BREAKAGE OF CLAMPING BOLTS ON S 4.0

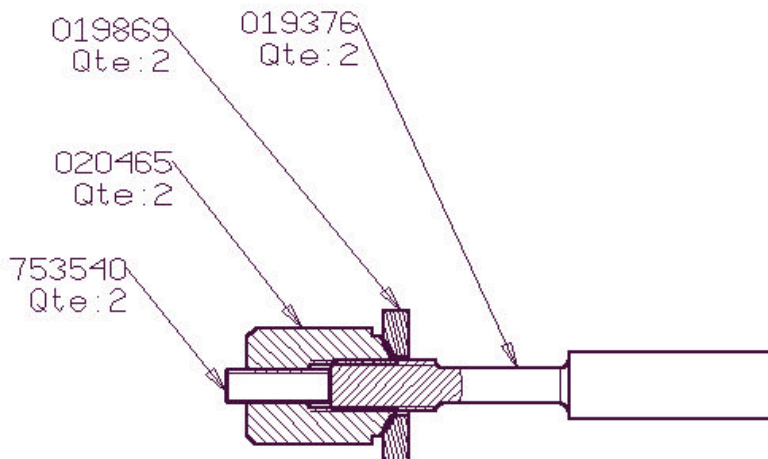
1 – A pressure limiter set to 3 bars (**ref. 025599**) is added onto the air supply of the big aluminium clamping jack in order to reduce the strain applied on the bolts but with keeping at the same time a good clamping of the workhead (see opposite picture).

In case of clamping bolt breakage, this modification can be done on any S 4.0.
Part reference to order is : **025599**.

Note: On the latest S 4.0 Power models the 125 mm diameter clamping jack has been replaced by a 100 mm diameter jack. Therefore pressure limiter is not needed.

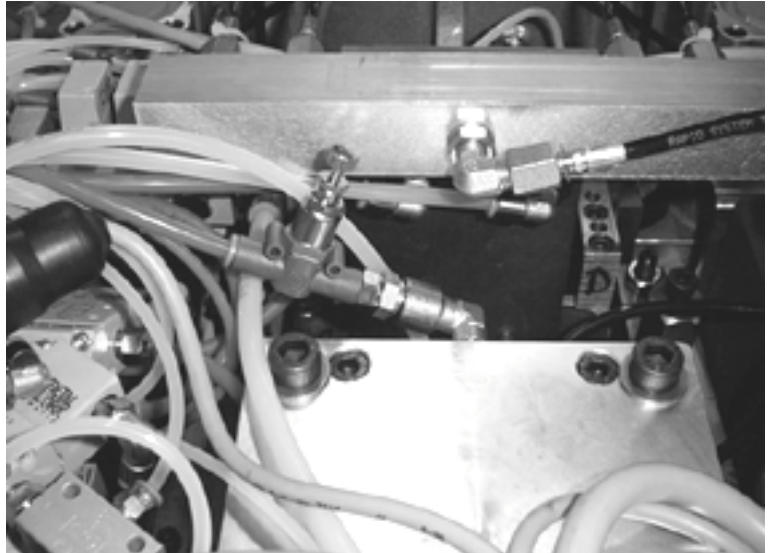
2 – The nuts (**ref. 020465**) which permits to set the position of the clamping bolts (**ref. 019376**) have been modified.

They have now on their bottom face a convex half-spherical shape which is in contact with a concave washer (**ref. 019869**; see picture). This permits to align the strains applied on the bolt with its axis. Therefore, the shearing strain which was causing the breakage is significantly reduced.

However to be perfectly efficient this modification needs a good setting of the clamping bolt position (See Technical Bulletin n°52).
